STAFF RECOMMENDATION
2409 Fairfax Avenue
June 17, 2015

Application: New construction—addition; New construction—Outbuilding; Setback determination

Description of Project: New construction of a rear addition and outbuilding. A setback determination is requested for the outbuilding, from twenty feet (20') to ten feet (10') off the alley.

Figure 2. 2409 Fairfax Avenue is marked in the box. The arrows point to neighboring properties to both sides with outbuildings that are a few feet off the alley.

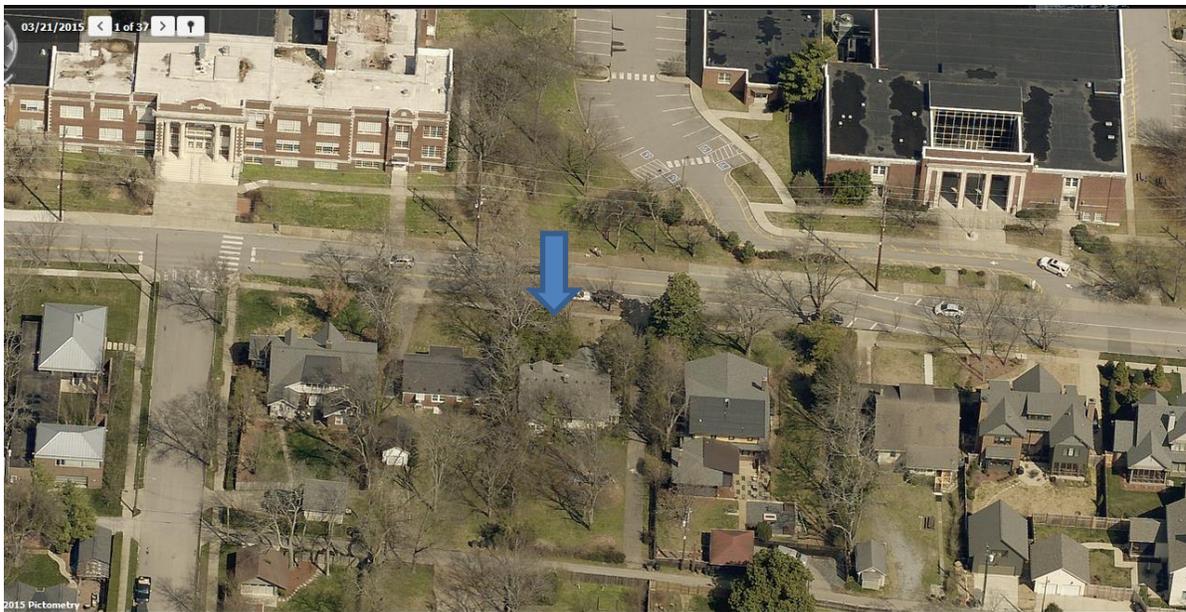
Outbuildings: The proposed outbuilding is one story and seven hundred and fifty-nine square feet (759 sq. ft.). The lot is more than twelve thousand square feet (12,000 sq. ft.), so an outbuilding up to one thousand square feet (1,000 sq. ft.) is permitted. Metro Code requires an outbuilding larger than seven hundred square feet (700 sq. ft.) to be twenty feet (20') from an alley. The proposed location is only ten feet (10'). As this is a common occurrence in the neighborhood, Staff recommends the setback determination to ten feet (10').

PROPOSED SITE PLAN

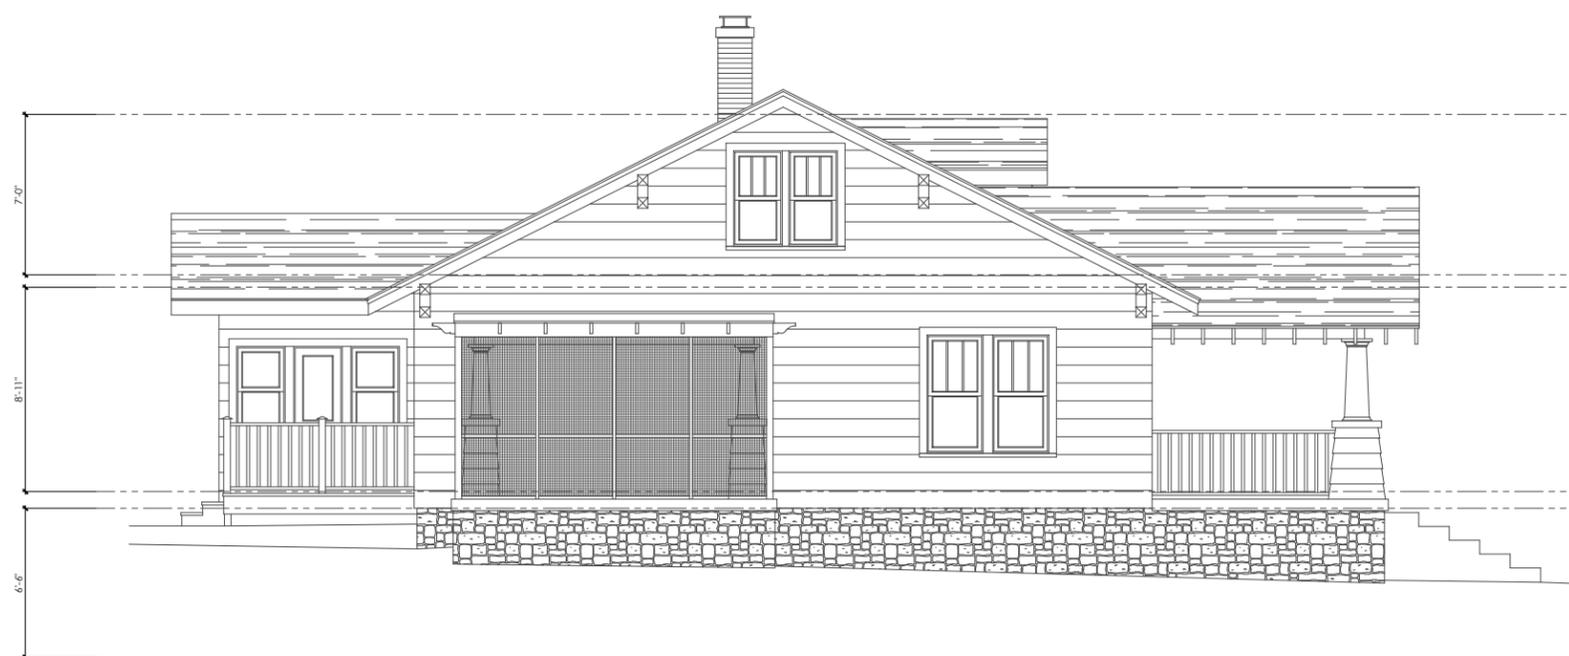
1. That Staff approves the final details, dimensions and materials of windows, doors and garage doors prior to purchase and installation;
2. That a revised site plan is submitted to reflect the correct driveway length.

Appurtenances & Utilities: The proposed changes to the site include a pool, a driveway off the alley, and walkways. The site plan shows the existing driveway being shortened to a point that it would be front-yard parking; the applicant has agreed to continue the existing driveway at least to the midpoint of the house to avoid this condition. Staff requests a revised site plan be submitted as a condition of approval. The project meets section II.B.1. I of the guidelines for appurtenances and utilities.

1. That Staff approves the windows, doors and garage doors prior to purchase and installation;
2. That a revised site plan be submitted to reflect the driveway length.
